**LOUISIANA  
POWER & LIGHT**

SUBJECT: Waterford SES Unit 3  
Docket No. 50-382  
Changes To Component Cooling Water System  
To Enhance Availability Of Cooling To  
Reactor Coolant Pump Seals

ENCLOSURES: (1) Description of Change and Safety Evaluation  
(2) FUSAR Change Request  
(3) Revised Control Wiring Diagrams

CLIENT: LOUISIANA POWER & LIGHT  
 PROJECT: WATERFORD 3 STEAM ELECTRIC STATION  
 SUBJECT: PROPOSED CHANGES TO CCWS TO SUPPLY CCW TO THE RCP'S.  
 SIMPLIFIED CCW FLOW DIAGRAM

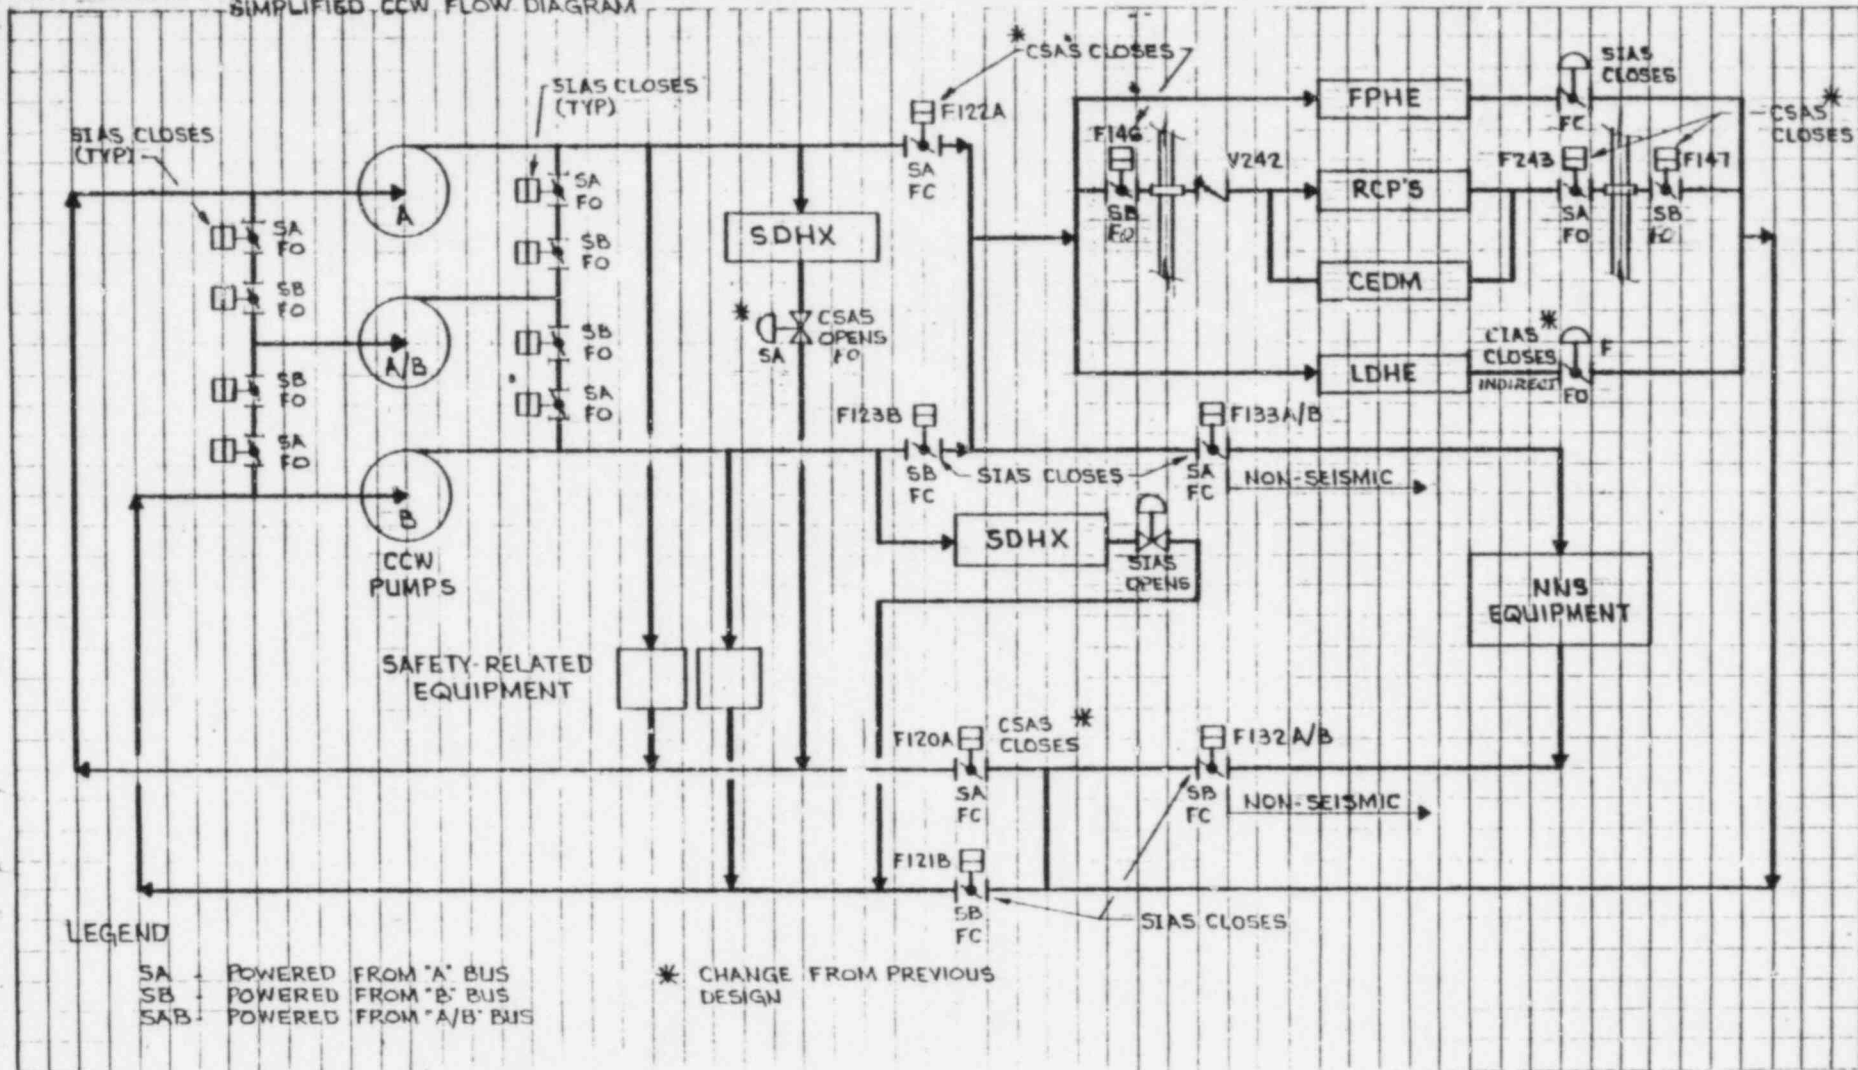
Upon SIAS or CIAS, the nonseismic, nonessential loop will continue to be isolated and the two redundant essential divisions of CCW will continue to be separated from each other. However, a flow path will be provided for CCW from the A train only to the RCP's and CEDM coolers. This will be accomplished by deferring closure of the header isolation valves on the A side (3CC-F120A, F122A) and the three CIV's from SIAS and CIAS, respectively to CSAS. Upon CSAS, the flow pattern of CCW and separation configuration will be exactly as it is now after SIAS or CIAS.

and from the RCP's will close on CSAS rather than CIAS. The two header isolation valves will also now close on CSAS rather than SIAS. The advantage of CSAS is that it is actuated on high containment pressure with an interlock with SIAS, so that SIAS must be actuated as a prerequisite for containment spray actuation. Actuation of CSAS, therefore, is a positive indication that there is either a LOCA event or a main steam line break in progress in the containment. In either event, the closure of the containment isolation valves in the CCW lines to the RCP's is in order.

Shutdown Heat Exchanger "A" Outlet Valve (3CC-F130A) - This valve will remain as is on SIAS and will open fully on CSAS. This is being done to reduce the demand on the "A" CCW pump which will be servicing the RCP's. The "B" SDHX outlet valve will continue to go full open on SIAS.

Fuel Pool Heat Exchanger TCV (3CC-TM138AB) - As before, CCW to the FPHX is isolated on SIAS. Now, however, SIAS will directly close this valve since the header valves on the "A" side will remain open on SIAS.

Letdown Heat Exchanger TCV (3CC-TM169AB) - The CCW to LDHX will be isolated but now it will close automatically when either letdown isolation valve, 2CH-F1518AB or 1CH-F2S01AB, on the CVCS side closes.

CLIENT: LOUISIANA POWER & LIGHT  
 PROJECT: WATERFORD 3 STEAM ELECTRIC STATION  
 SUBJECT: PROPOSED CHANGES TO CCWS TO SUPPLY CCW TO THE RCP'S.  
 SIMPLIFIED CCW FLOW DIAGRAM

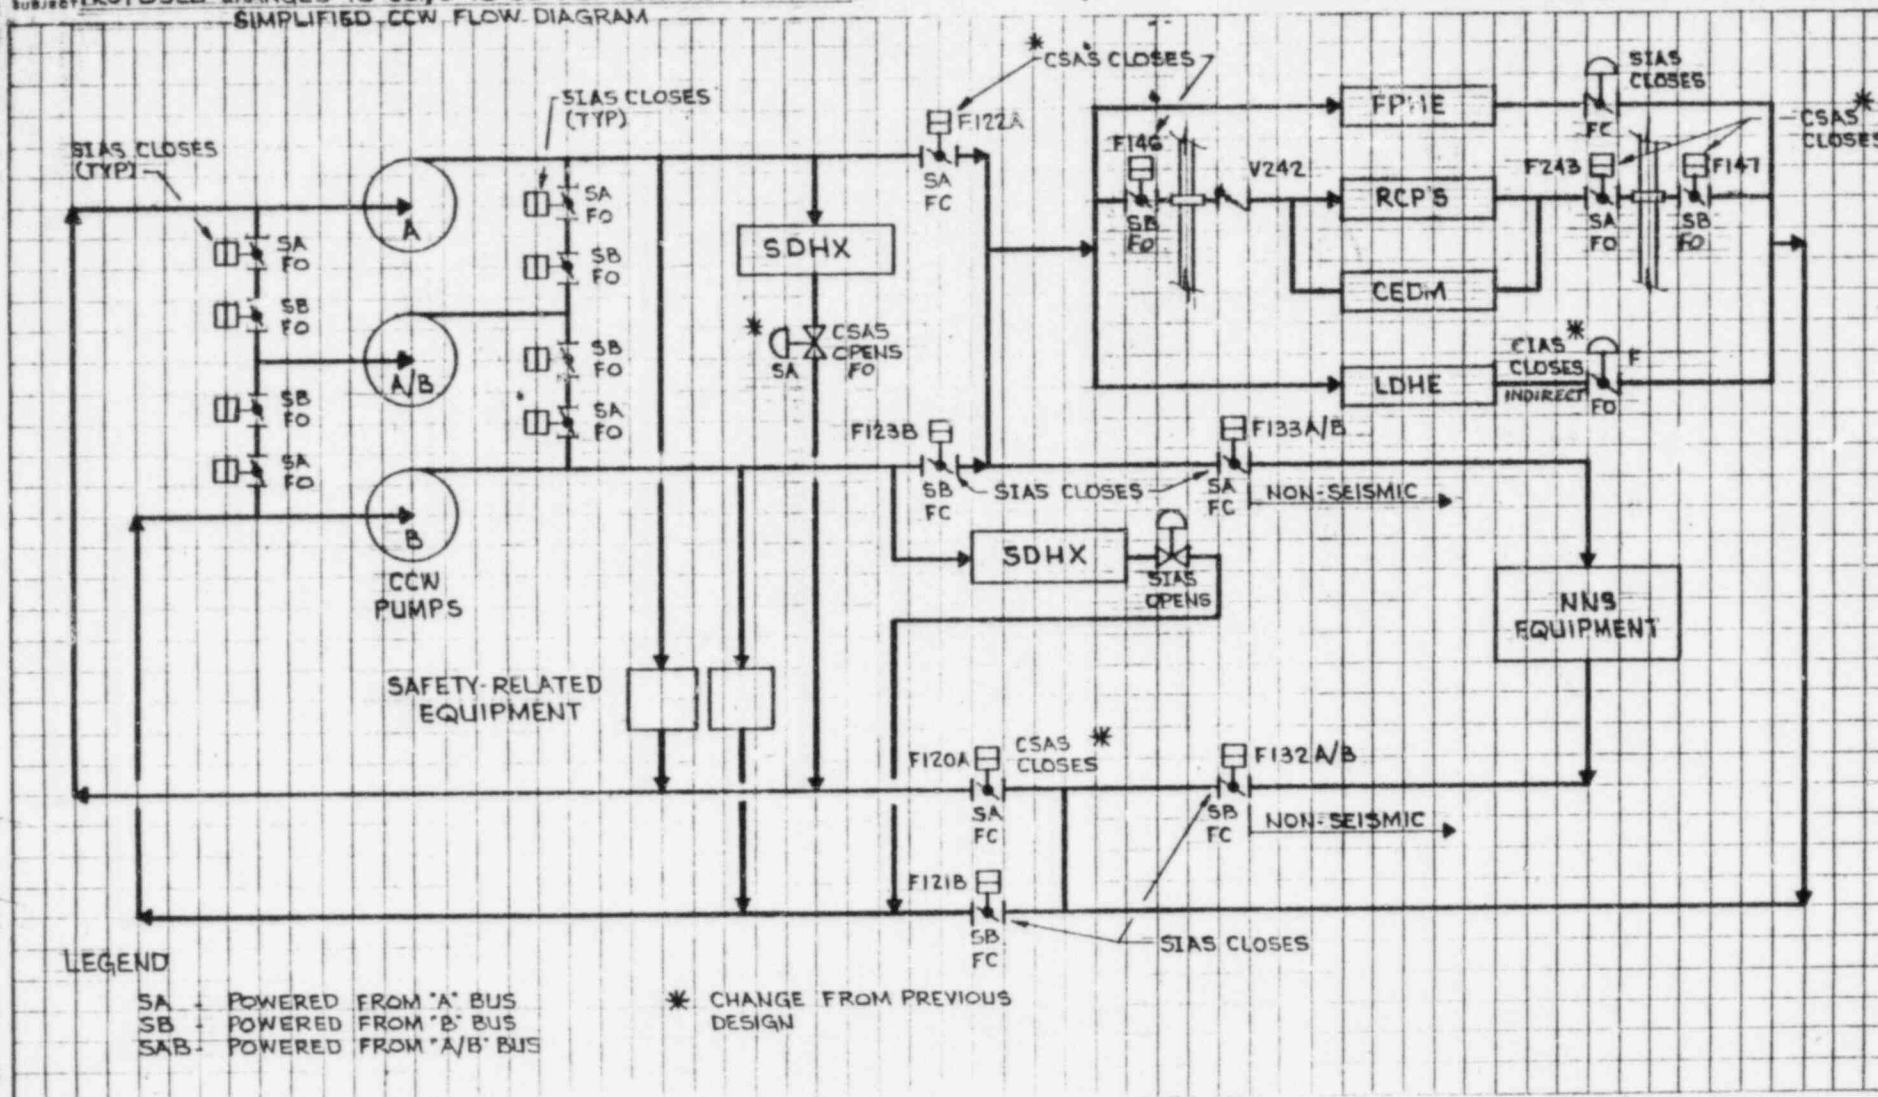
Upon CSAS, the containment isolation valves (2CC-F146A/B, 2CC-243A/B, 2CC-F147A/B) on the supply and return lines of CCW to the Reactor Coolant Pumps and CEDM coolers are automatically isolated, and the outlet valve (3CC-F130A) on the A shutdown heat exchanger goes full open automatically.

ERASCO SERVICES INCORPORATED  
DIV. I & C DR. REL  
CM MAZIEMSKI  
DATE JUN 21, 1977  
LOUISIANA POWER & LIGHT CO.  
WATERFORD S.E.S. UNIT No.3  
CONTROL WIRING DIAGRAM  
COMPONENT COOLANT TRAIN A ISOL VA'S  
3CC-F120A & 3CC-F122A  
LOU-1564  
B-424  
SHEET 8348

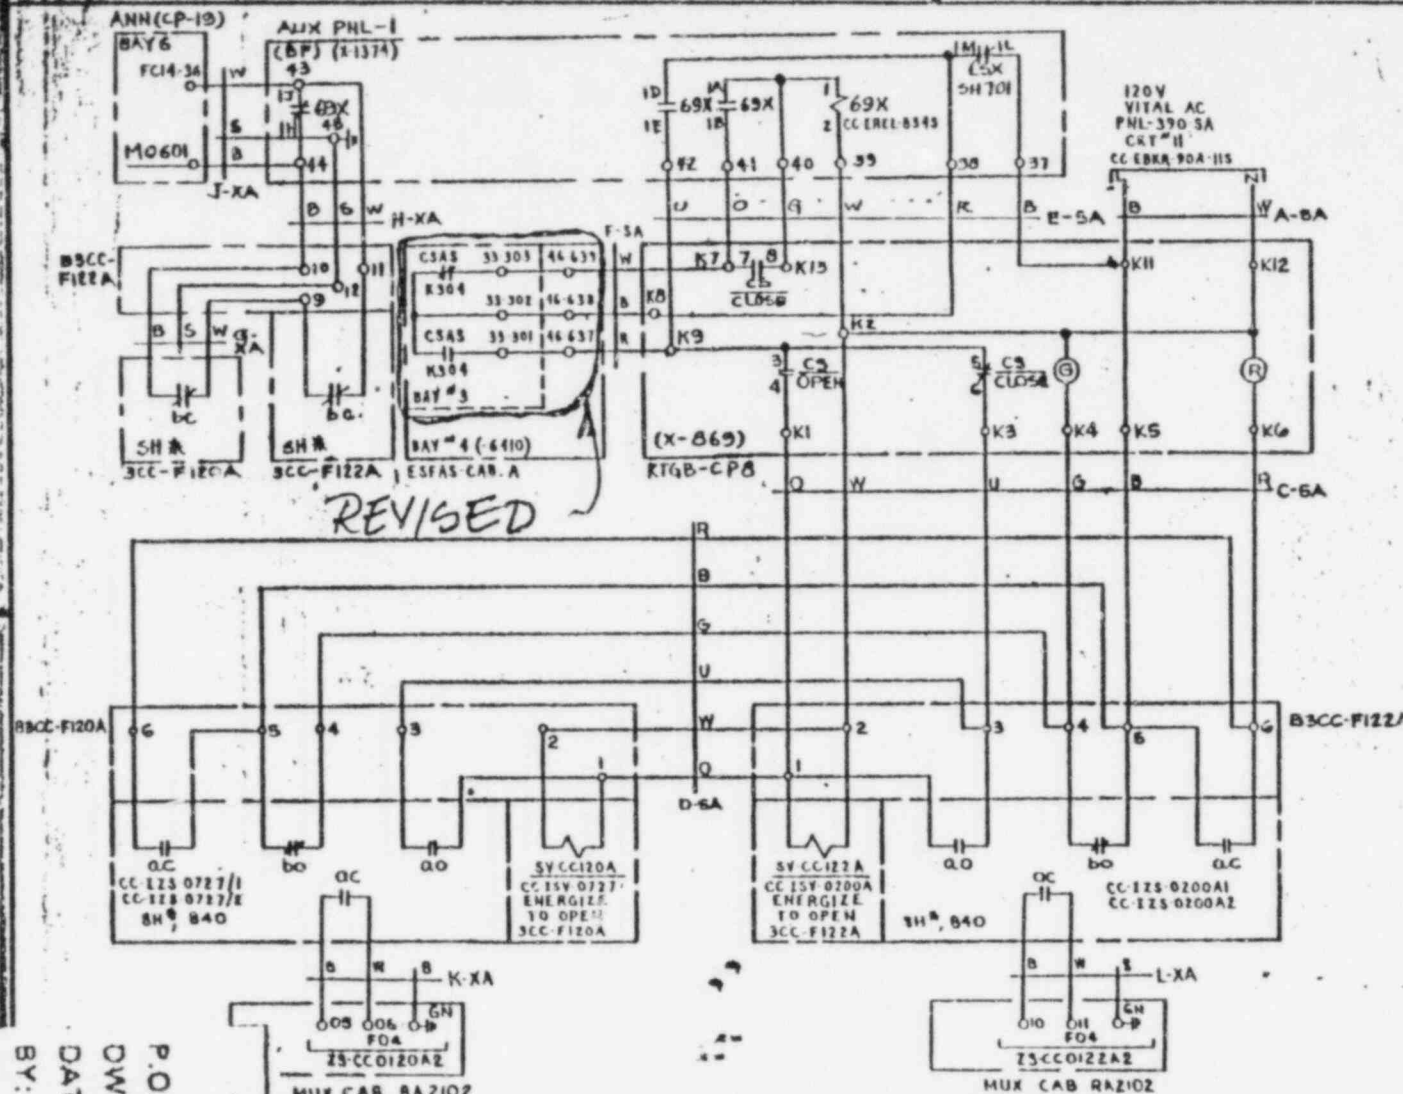
CCW TRAIN A  
ISOLATION VA'S

**DELETE**

LOUISIANA POWER & LIGHT CO.  
WATERFORD S.E.S. UNIT No.3  
CONTROL WIRING DIAGRAM  
COMPONENT COOLING WATER FROM RCP'S ISOL  
VALVES 2CCF243A/B & 2CCF147A/B

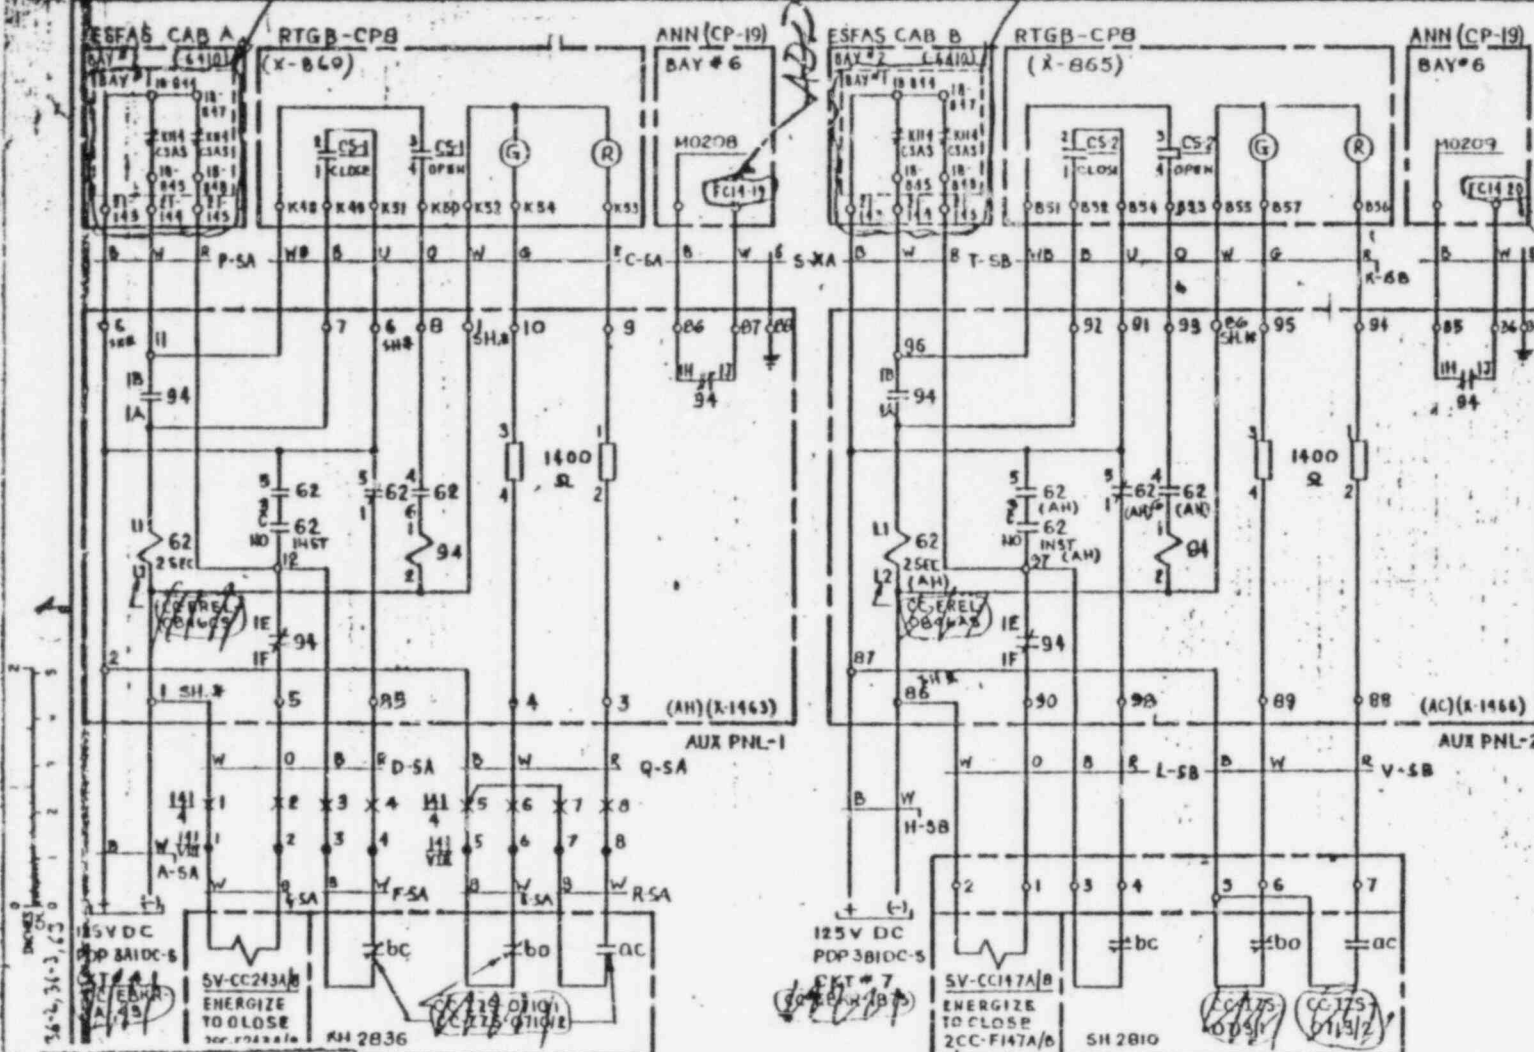
DELETE

(CS-1) CCW FROM RCP'S  
ISOL VA IN

(CS-2) CCW FROM RCP'S  
ISOL VA OUT

ADD (DRAFTING ONLY)

LOUISIANA POWER & LIGHT CO. LOU-1564  
WATERFORD S.E.S. UNIT No.3 B-324  
CONTROL WIRING DIAGRAM  
SHUTDOWN HEAT EXCHANGER A. SHEET 157  
OUTLET VA 3CC-F130A 3-179

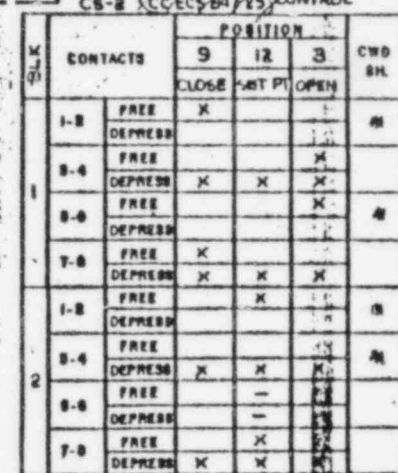
• DELETE / ADD
